Amendment No. 3 to Provisional Operating License No. DPR-16 is enclosed. The amendment authorizes the operation of the Oyster Creek Nuclear Power Plant Unit No. 1 at steady state power levels up to 1930 megawatts (thermal).

AMENDED FACILITY LICENSE

Amendment No. 3  
License NO. DPR-16

CHANGE NO. 7 TO APPENDIX A

FIGURE 2.1.1

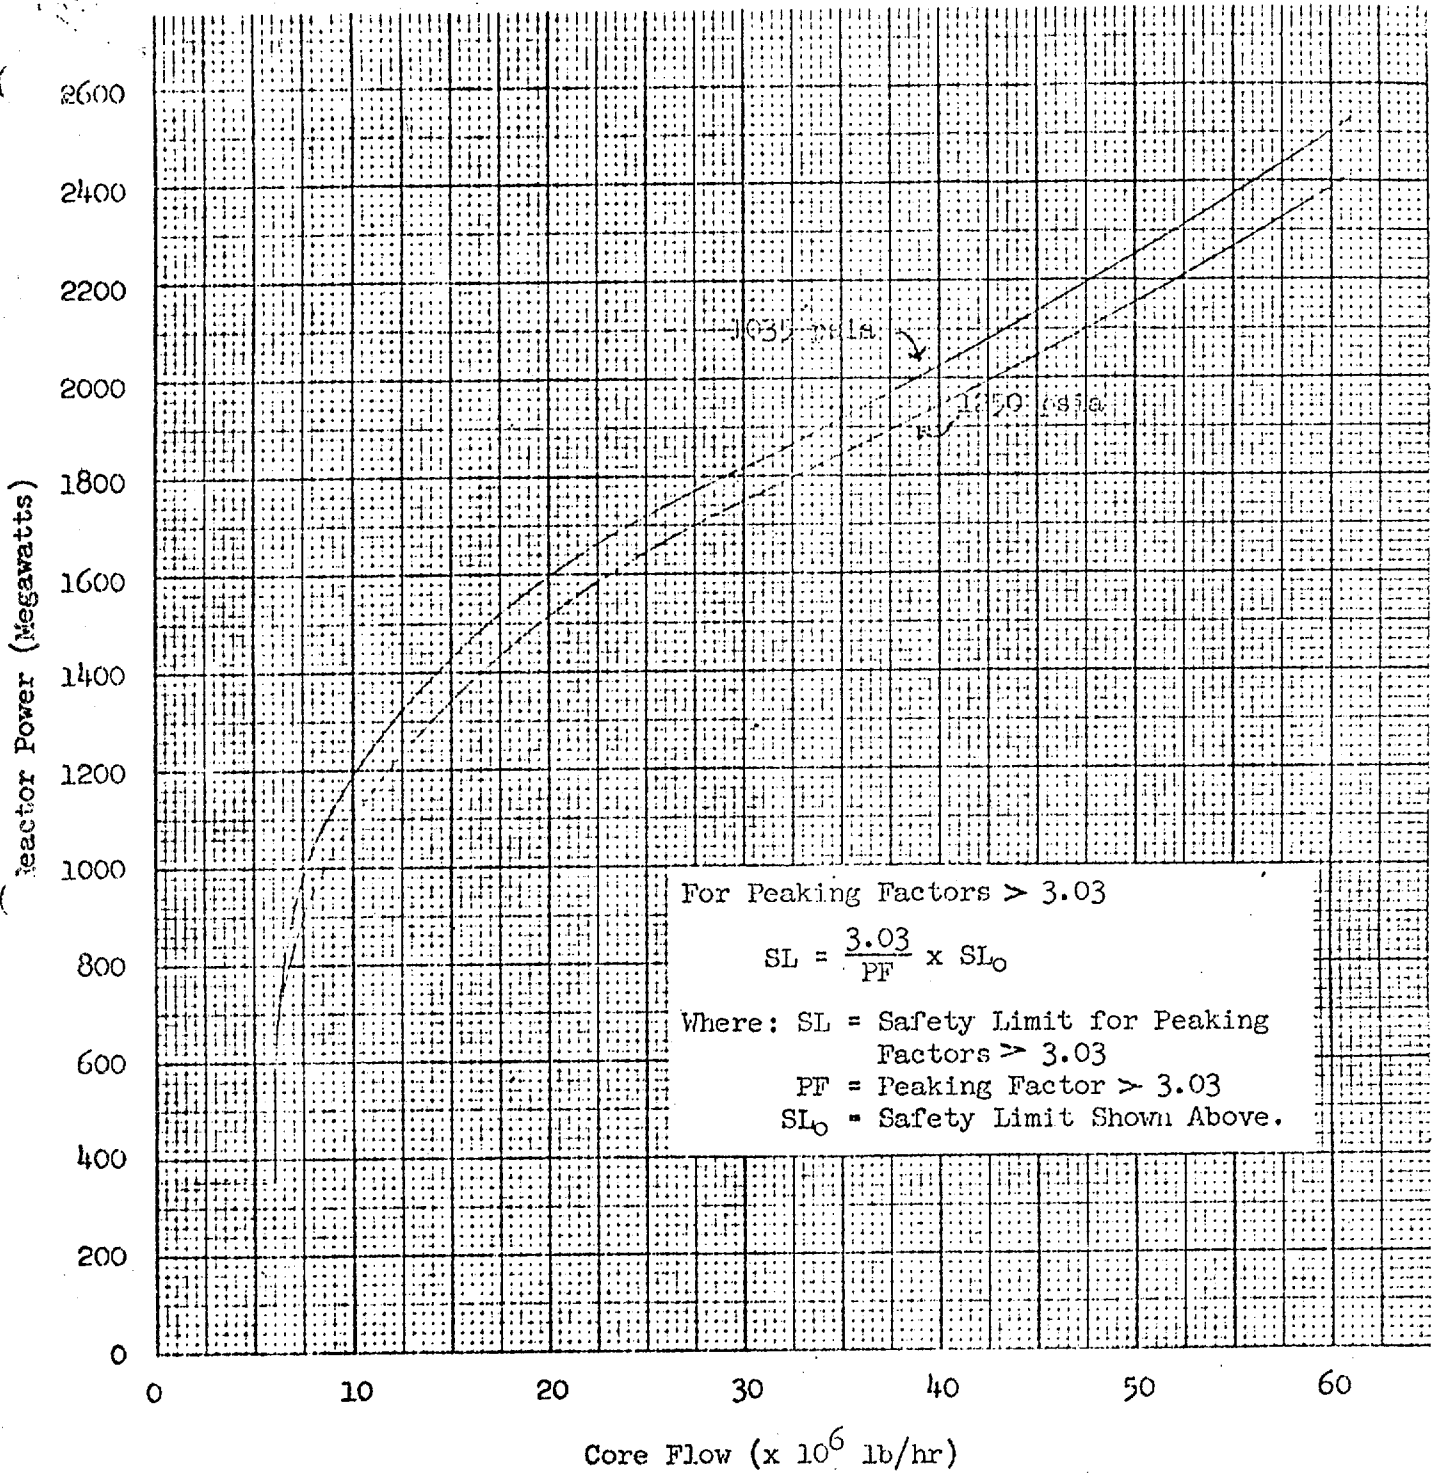
- (1) Replace Figure 2.1.1, Fuel Cladding Integrity Safety Limit (Revised December 2, 1970) with Figure 2.1.1, Fuel Cladding Integrity Safety Limit (Revised 11/5/71).

FUEL CLADDING INTEGRITY SAFETY LIMIT  
 (Revised 11/5/71 )
